CALIFORNIA COASTAL COMMISSION

STAFF REPORT: REVISED FINDINGS

APPLICATION NUMBER: 5-01-409
APPLICANT: Robert and Nancy Conger
AGENT: GWC Architects, Attn: Gerald Compton
PROJECT LOCATION: 501 Paseo de la Playa, City of Torrance, Los Angeles Co.

SLOPE STABILITY ANALYSIS 501 PASEO DE LA PLAYA, TORRANCE, CA		
SCALE: 1" = 20'	APPROVED BY:	DRAWN BY: AFD
DATE: JULY 00		REVISED: AFD
COASTLINE GEOTECHNICAL CONSULTANTS		
PROJECT NO. 1601C-071		FIGURE 2

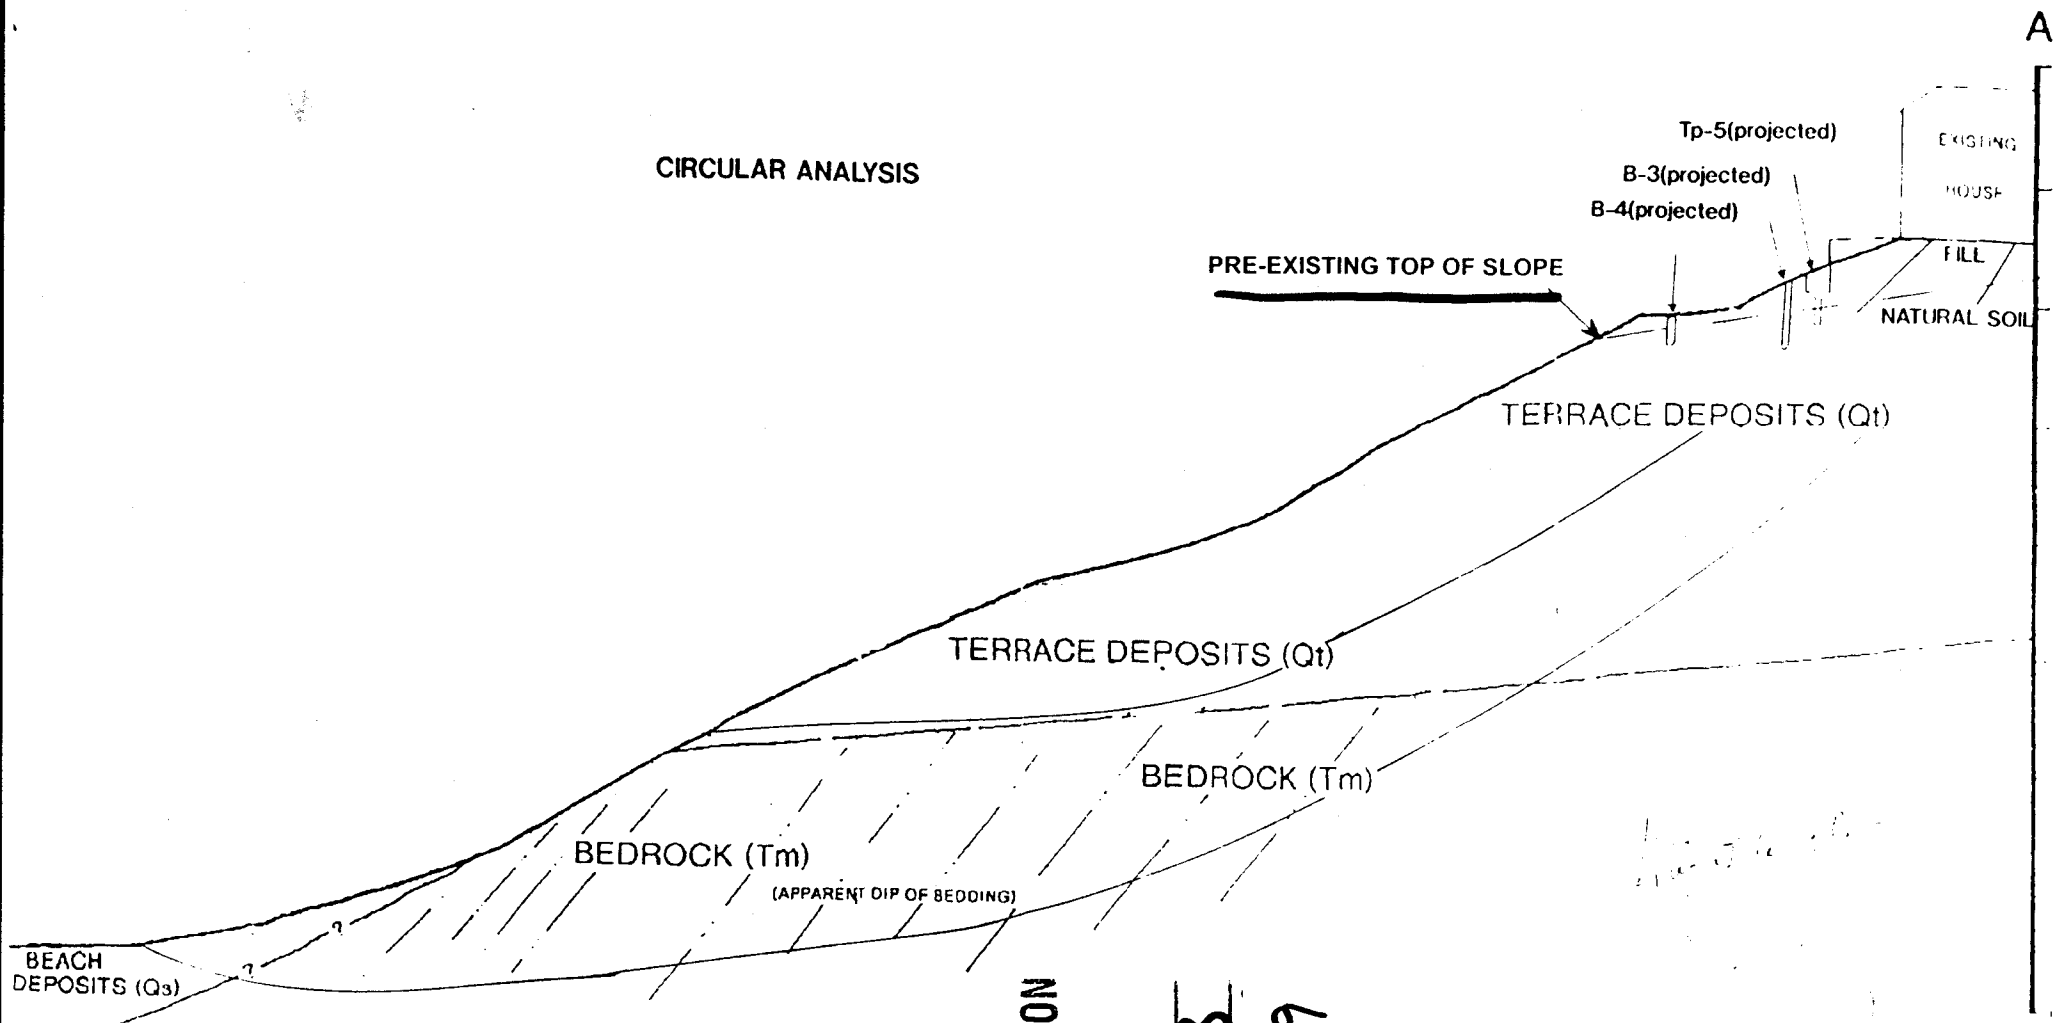
The Commission's senior geologist reviewed the geology report, the geotechnical engineering reports and wave impact study report prepared for the site. Based on these reports, he commented that the minimum setbacks for the house footings and the spa that are required by the City are adequate to ensure stability of the bluff under current conditions and he concurs that the site is grossly stable. However, he points out that uncontrolled drainage could change these conditions—continued surficial creep could occur and instability could increase markedly if the erosion caused by the defective storm drain that is located on the bluff face is not repaired. More importantly he points out that the applicant's geologist has not established a safe building line.

References (4) and (5) together address other geologic hazards at the site, as well as provide criteria for foundation design. The lower slope is underlain by the Monterey Formation, which is known to be subject to landsliding, but in this area the bedding dips to the north, nearly at right angles to the trend of the bluff, so bedding planes are not exposed on the bluff face. The upper slope is underlain by marine terrace deposits. A quantitative slope stability analysis in reference (5) demonstrates that the slope is globally stable (factor of safety of 1.8 static, 1.2 pseudostatic) with respect to sliding. The report does not show the location of the hypothetical failure surface corresponding to this factor of safety, so there is no way of identifying the way to establish setbacks behind a line corresponding to a particular factor of safety. Reference (5) also reports a 1.6 factor of safety against surficial sliding, using the method of infinite slopes. Nevertheless, it is acknowledged that slope is "partially unstable," and is subject to creep. Significant erosion is occurring on the lower third of the slope due to leakage from a corroding storm water drain. I concur with the assessments of references (4) and (5) that the slope is currently grossly stable, but that continued surficial creep, slumps, and gulleying are to be expected. Instability could increase markedly if the erosion caused by the defective storm water drain is not repaired. ...

Sec. 1806.4.2

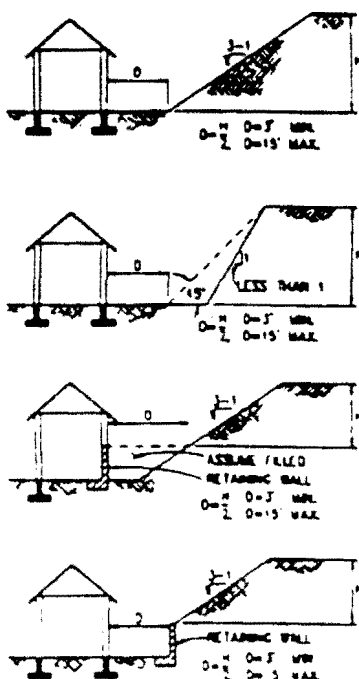
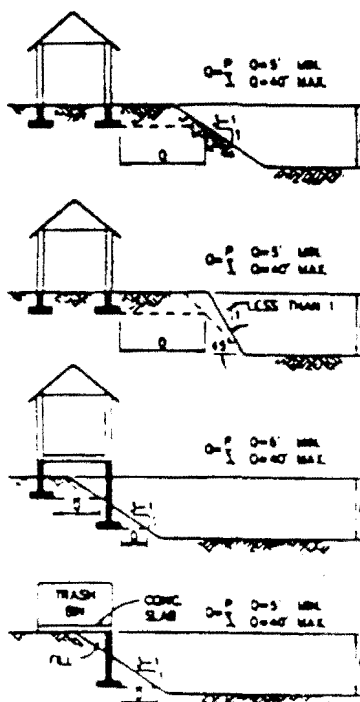
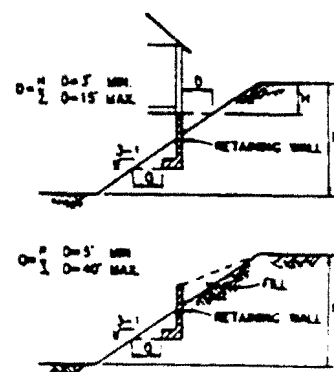
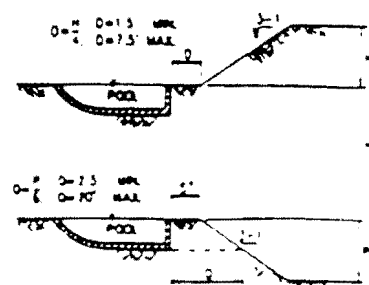
Several conclusions, requirements and recommendations were made in the geotechnical engineering investigation report. The City of Torrance requires a foundation slope setback for the placement of structures on, or adjacent to, slopes steeper than 3:1 (horizontal to vertical) to provide protection from water, mudflow, loose slope debris and shallow slope failures. The setback is the horizontal clearance from the face of the foundations to the lower edge of cut slope, which is the top of the steeper than 3:1 slope. The report refers to and includes a copy of the City's information sheet for slope setback requirements (Exhibit #8, p.3). For the proposed project, the information is used to determine the required setback for footings and spas from the descending slope surface, which is the lower edge of cut slope.

The foundation slope setback, required by the City of Torrance, is for the placement of buildings and structures on, or adjacent to, slopes steeper than 3:1 (horizontal to vertical) to provide protection from water, mudflow, loose slope debris, and shallow slope failures. This setback, shown on Plate A, is the horizontal clearance from the face of the foundations to the slope face.
